UNITED STATES PATENT AND TRADEMARK OFFICE

Office Action Summary

10/804,711

DETAILED ACTION

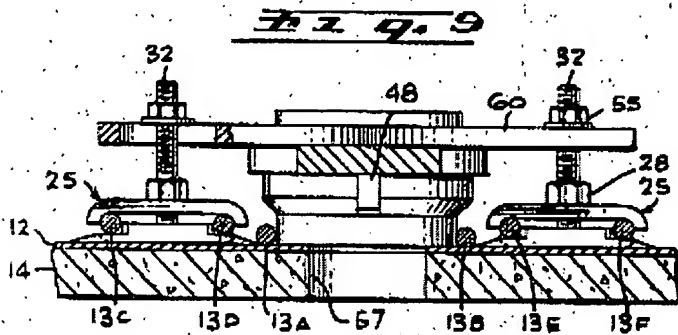
Ohnstad discloses a method of reinforcing a cylindrical pipeline, wherein pre-stressing reinforcements (13) are placed and tensioned around the pipeline, wherein in a zone where the pipeline has a radial projection (17) on a first side, the pre-stressing reinforcements are deflected to bypass the projection, and wherein the reinforcements located in a common layer on a second side opposite the first side are

distributed in a plurality of layers on the first side.

As shown above reinforcements (13C, 13D, 13E and 13F) are in a different layer as (13A and 13B), as recited in claims 1 and 12. The means for deflecting the reinforcements includes a plate (12) having an orifice for providing passage for the radial projection and channels in the form of grooves on member (30) for guiding the reinforcements, as recited in claims 2, 3, 13 and 14.
